**Community Baptist Church**  
**4703 N Ankeny Blvd**

*Plan and Zoning Commission  
Staff Report*

**Agenda Item:** 4703 N Ankeny Blvd – Community Baptist Church Site Plan  
**Report Date:** November 16, 2017  
**Prepared by:** Eric Carstens, AICP  
Planning Administrator

Utility Plan

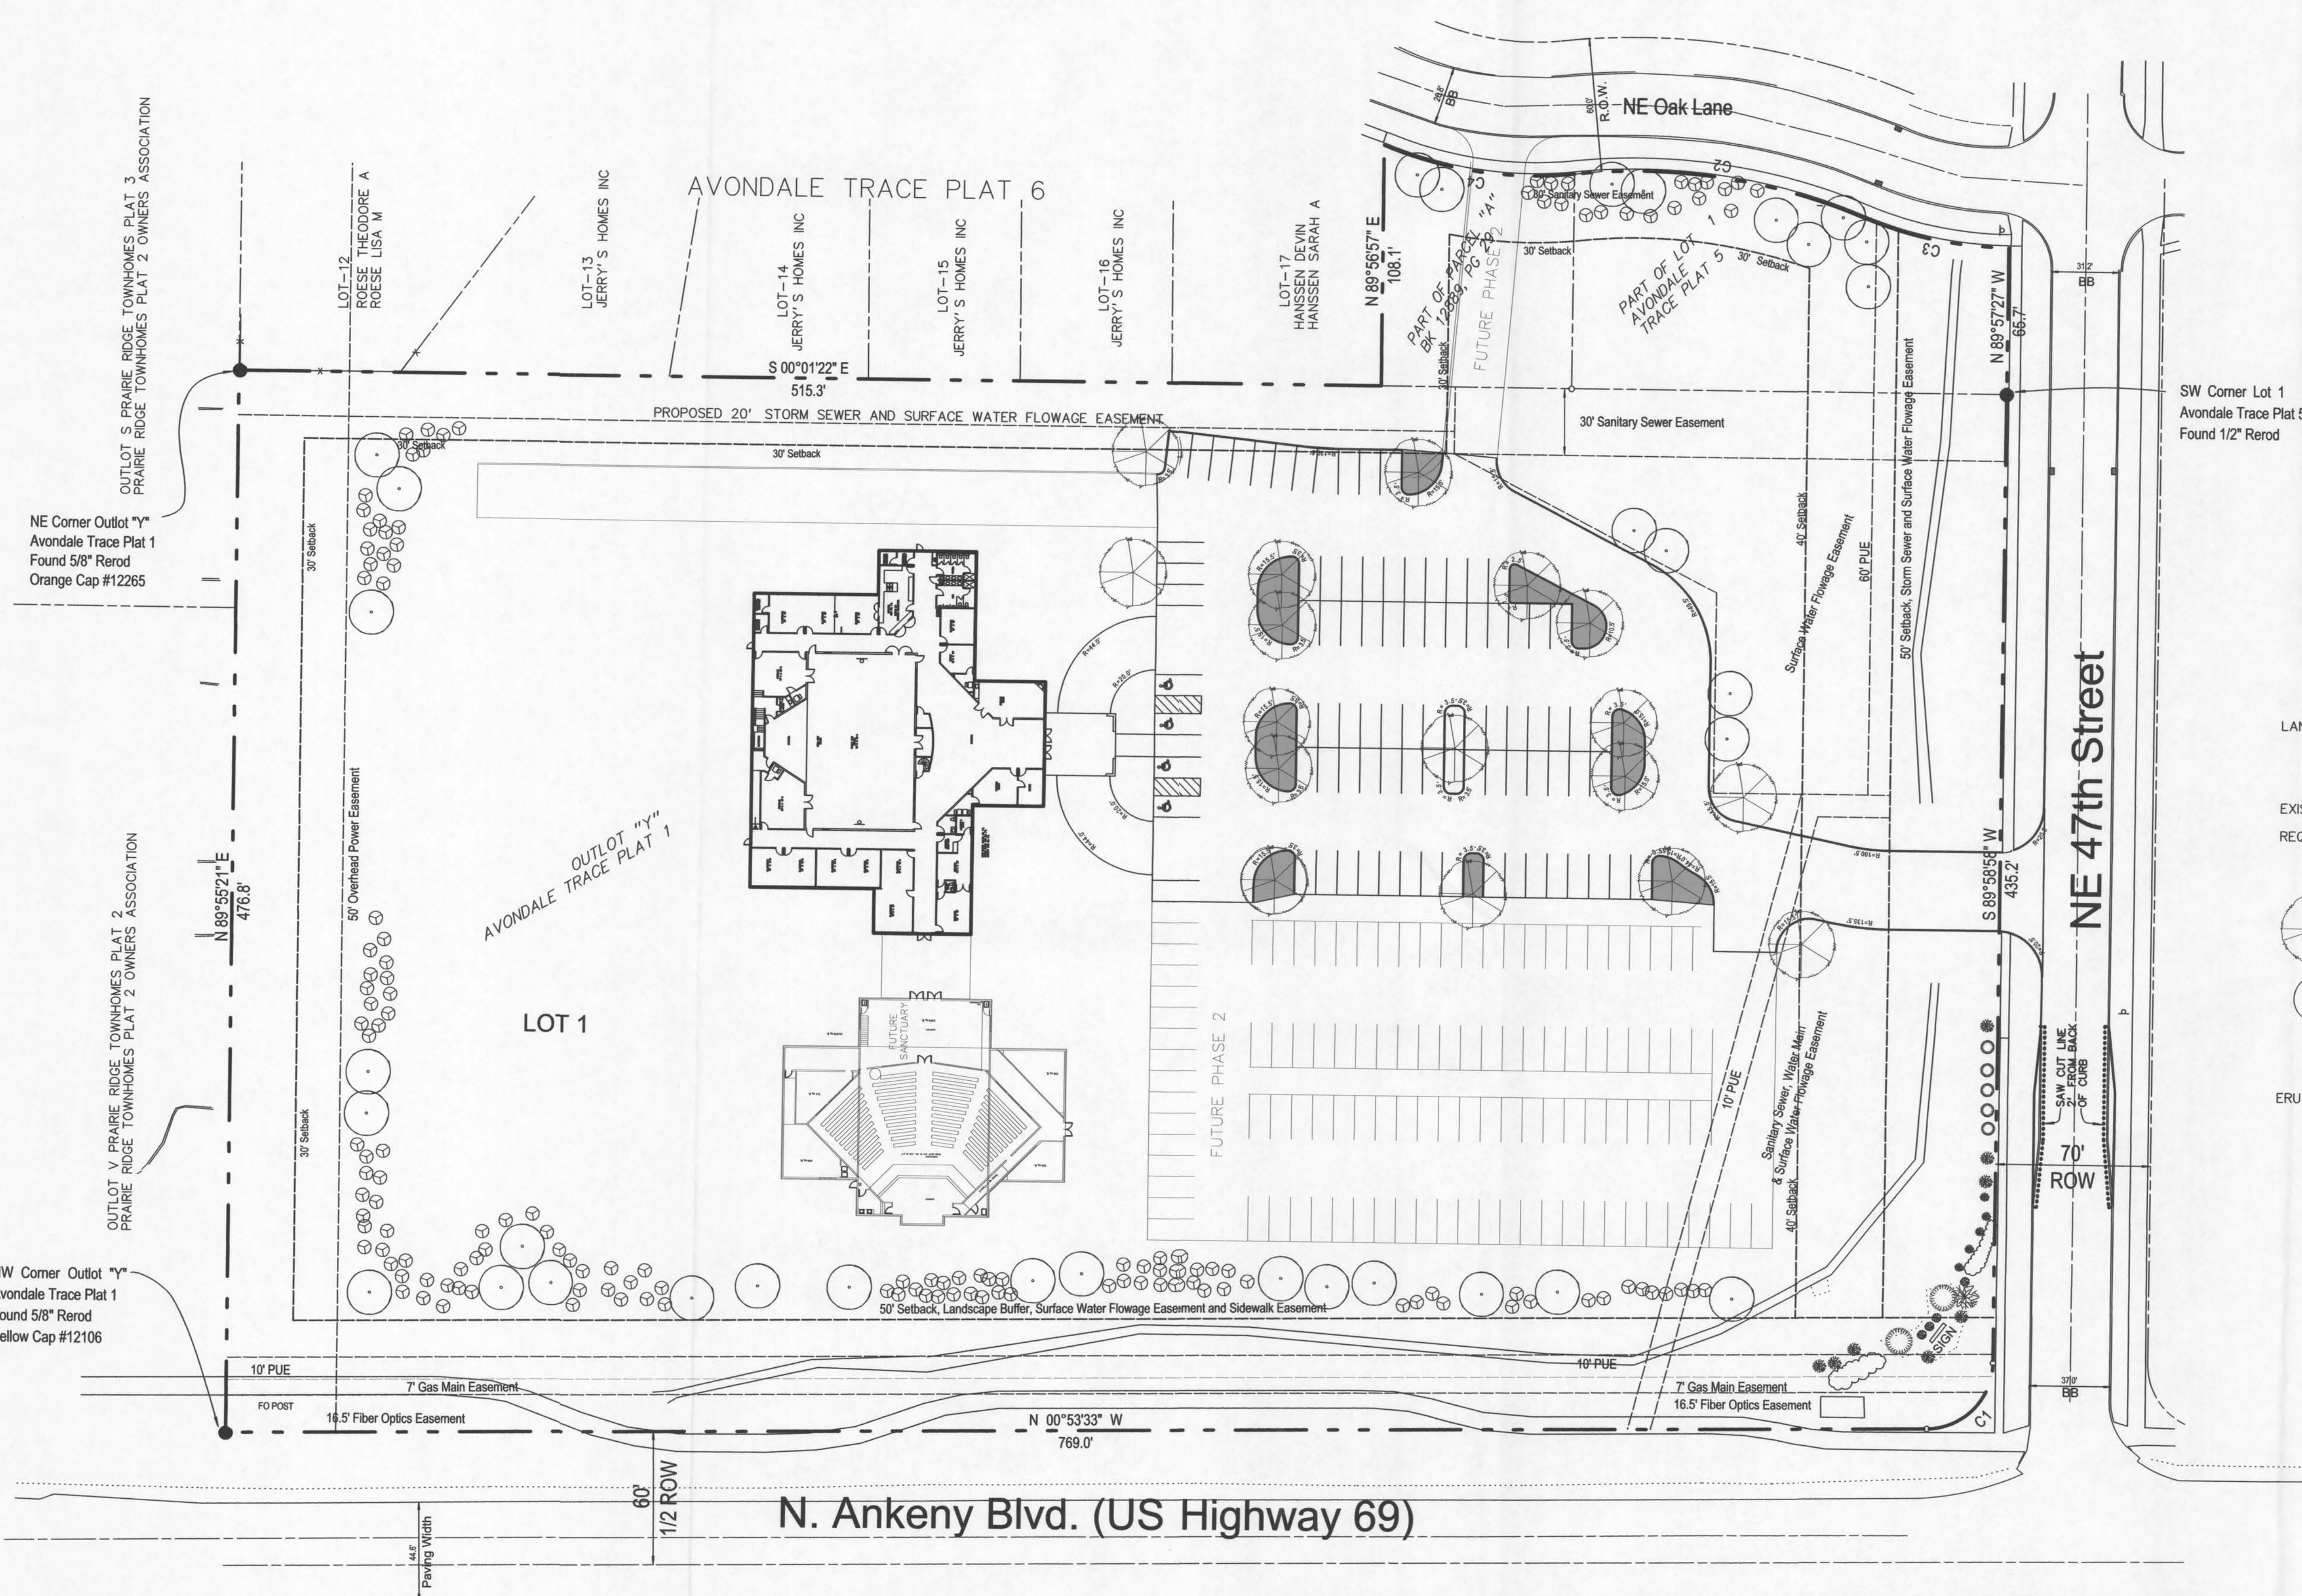
The applicant proposes to connect to existing 10" water service along NE 47<sup>th</sup> St, and 8" sanitary sewer service along the east plat boundary. 8" water and 6" sanitary lines will be used to service the site.

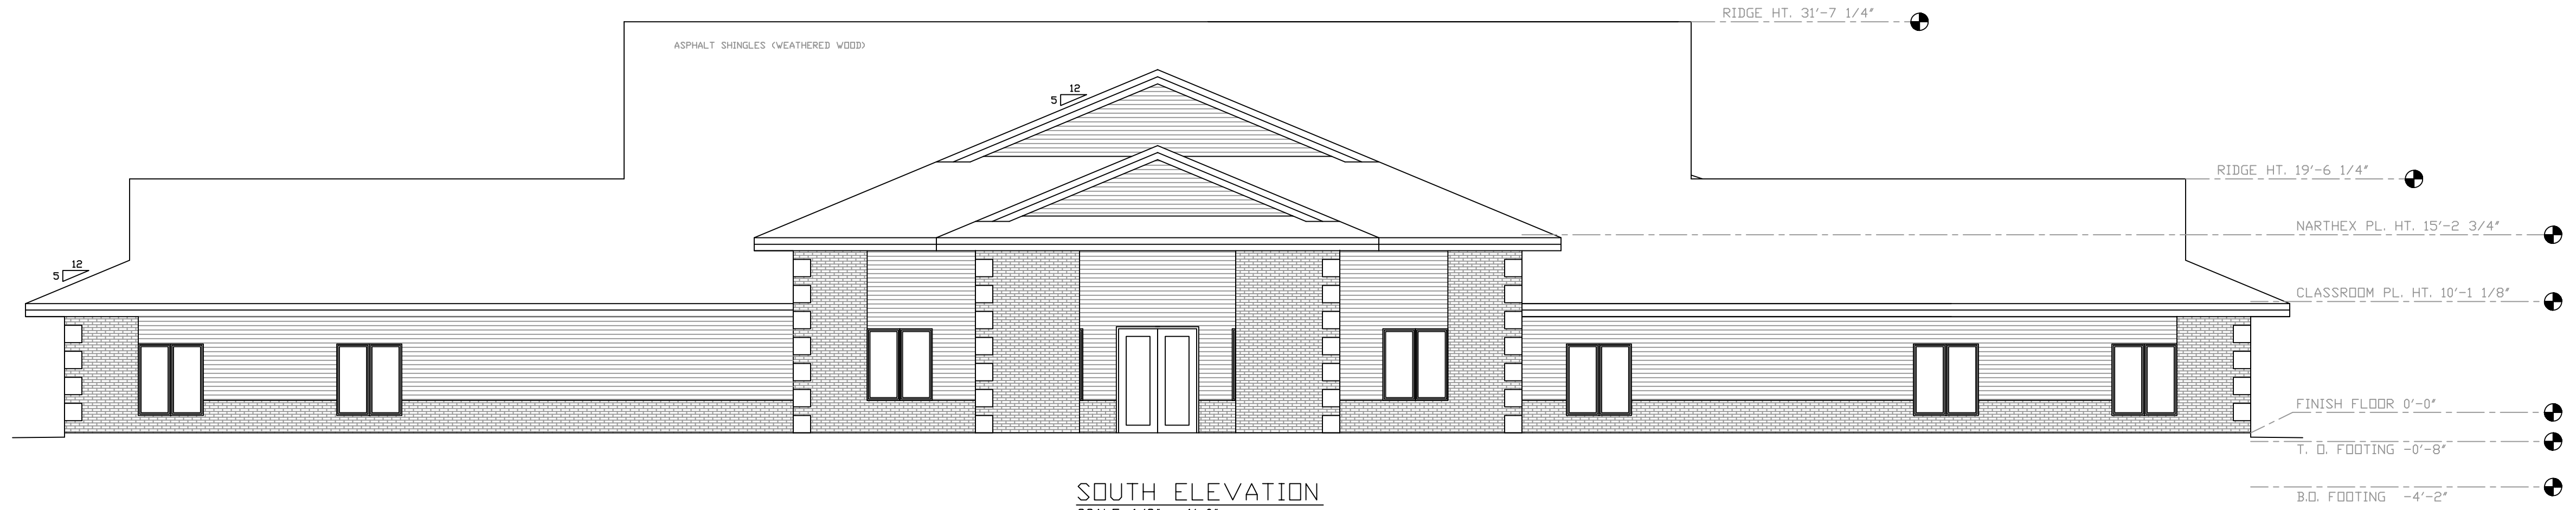
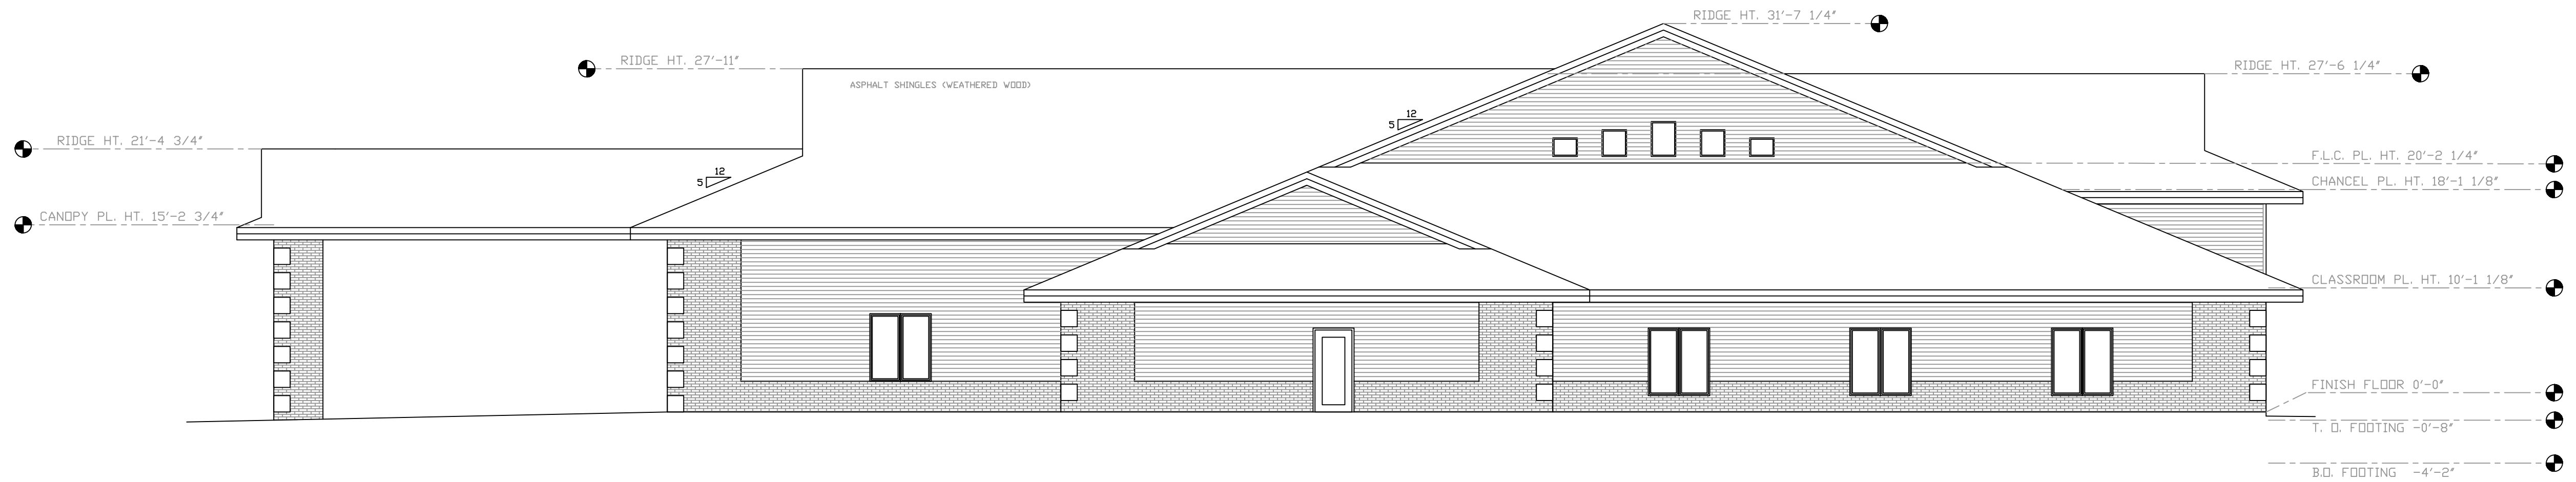
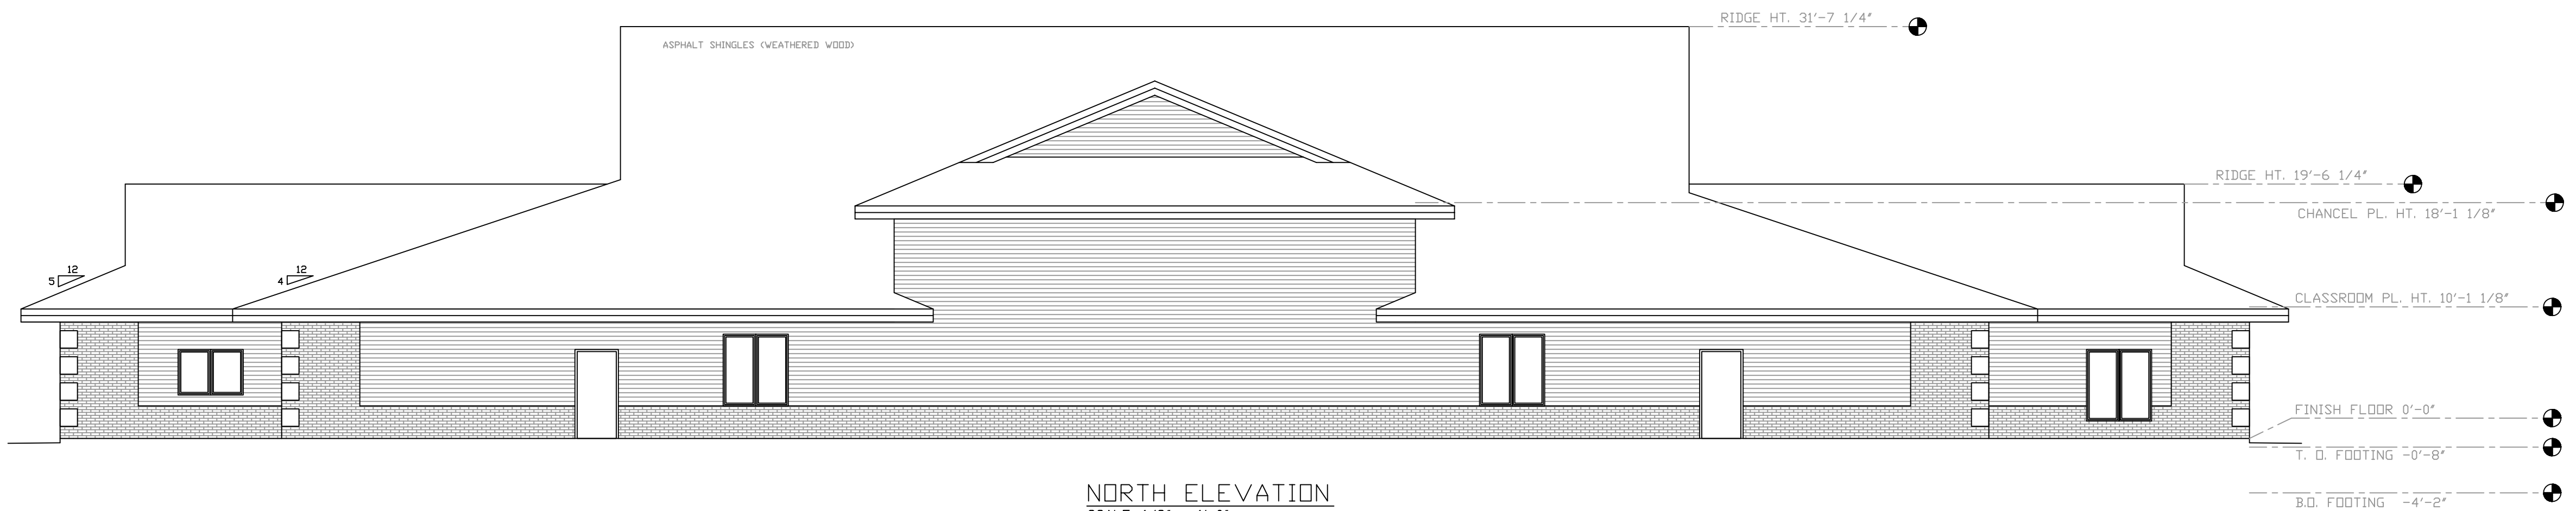
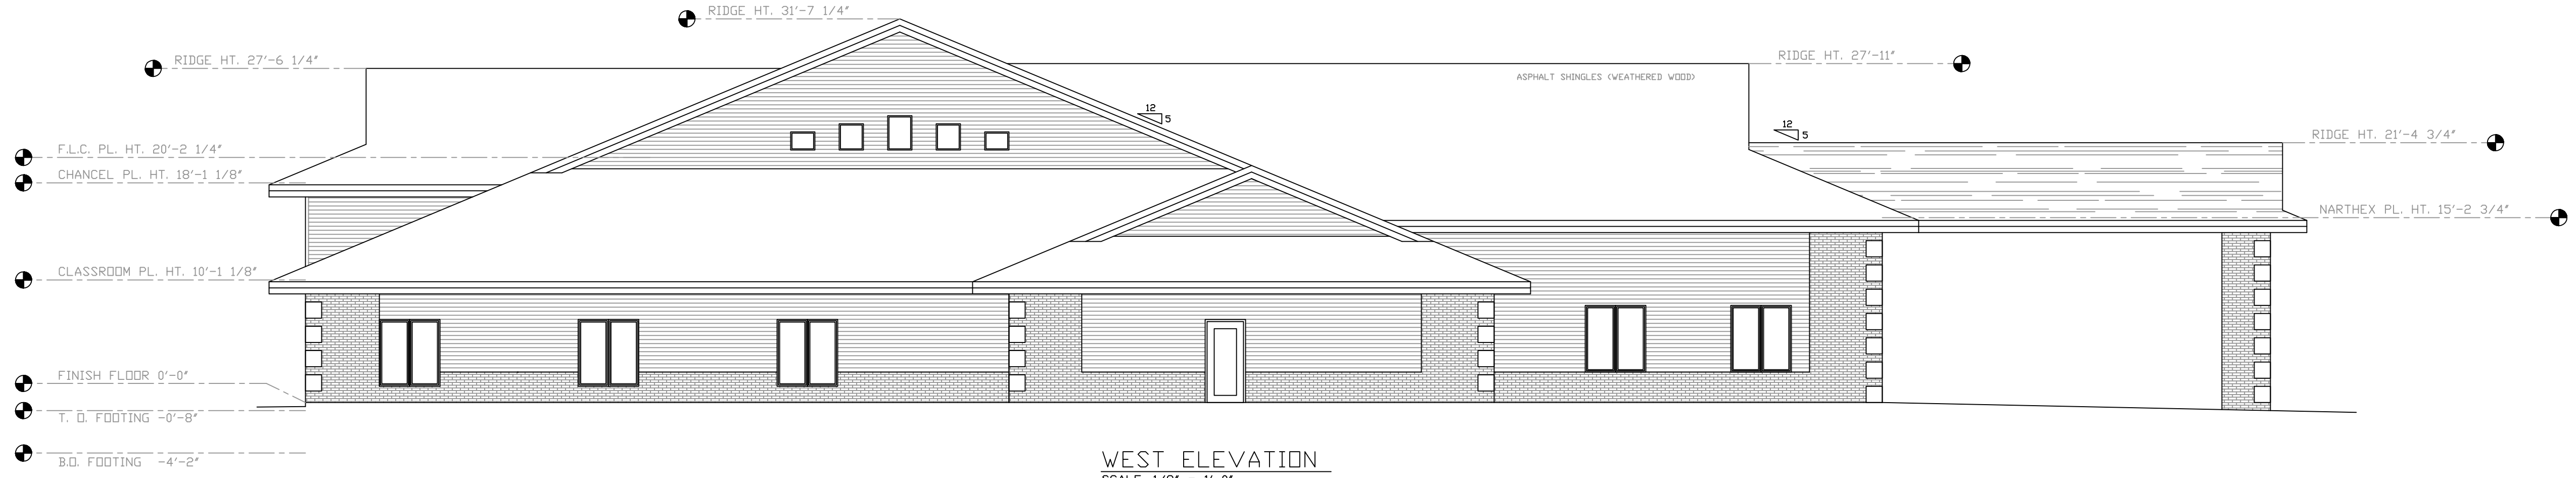
The uppermost ridge height of the proposed building is 31'-7". Other roof line heights are 19'-6" and 27'-6". There are buildings in the general vicinity with similar scale.

The proposed building materials are brick and steel siding.

There are no proposed building signs shown on the elevations. Future sign allowances will be determined with future sign permits in conformance with the sign code.
